Work Order ID 79933

Item Name: Crosstube Fwd

DART AEROSPACE LTD	Work Order:	79933
Description: Crosstube High Fwd (407)	Part Number:	D407-667-105
Inspection Dwg: D407-667-145	Rev: C	Page 1 of 1

DRAWING NO. D407-667-145	TITLE CROSSTUBE ASS'Y (407 HIGH FWD)	REV. C	DART AEROSPACE LTD ENGINEERING ORDER		D.E.O. NO. D407-667-145-C-1	SHEET NO. SHEET 1 OF 1	SCALE NTS
DRAWN 97	CHECKED 155	MFG. APPR. 155	APPROVED WD		DE APPR. 155		
DATE 11.07.15	DATE 11.07.22	DATE 11.07.22	DATE 11/07/22		DATE 11.07.21

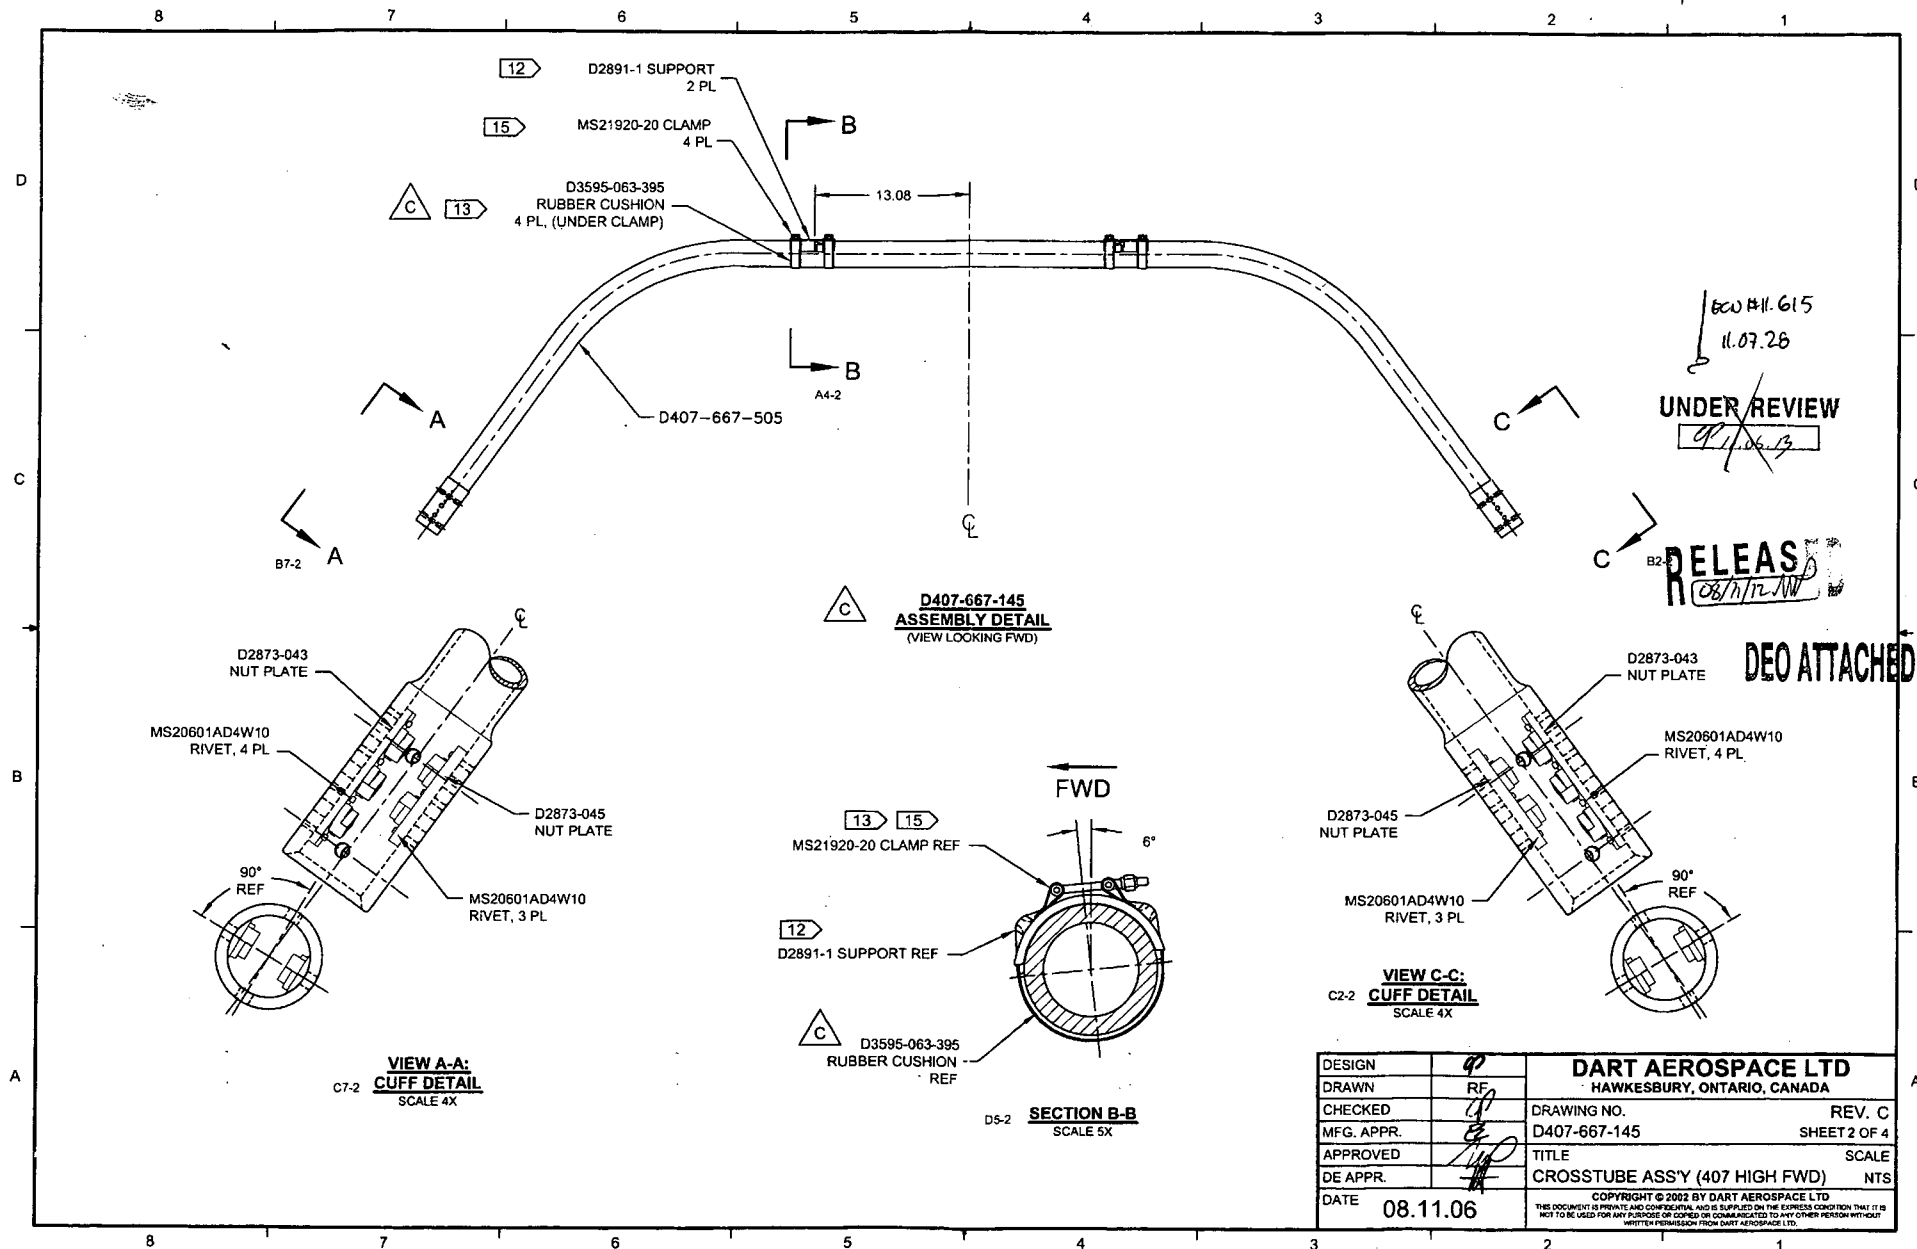
C	REVISE GENERAL NOTES/PART LIST (ZN D7-1); REORGANIZED VIEWS AND REFORMATTED DRAWING TO CURRENT STANDARDS. D3595-063-395 WAS D2856-400-694 (ZN D6-2 & A5-2); REMOVED REF. 7 ADD TOLERANCES (ZN C6-3, C4-3, D2-3); RELOCATED FLAG #6 (ZN A5-3) PER NCR 210; MOVED TURNING DETAIL & UPDATED TOLERANCE TO SHEET 4.	RF	08.11.06
B	ADD HOLES AND NUT PLATES FOR COMPATABILITY WITH BHT/AA SKUDTUBES	PH	05.07.26
A	NEW ISSUE	CP	02.05.08
REV.	DESCRIPTION	BY	DATE
DESIGN	RF	DART AEROSPACE LTD HAWKESBURY, ONTARIO, CANADA	
DRAWN	RF	DRAWING NO.	REV. C
CHECKED	RF	D407-667-145	SHEET 1 OF 4
MFG. APPR.	RF	TITLE	SCALE
APPROVED	RF	CROSSTUBE ASS'Y (407 HIGH FWD)	NTS
DE APPR.	RF	COPYRIGHT © 2002 BY DART AEROSPACE LTD THIS DOCUMENT IS PRIVATE AND CONFIDENTIAL AND IS SUPPLIED ON THE EXPRESS CONDITION THAT IT IS NOT TO BE USED FOR ANY PURPOSES OR COPIED OR COMMUNICATED TO ANY OTHER PERSON WITHOUT WRITTEN PERMISSION FROM DART AEROSPACE LTD.
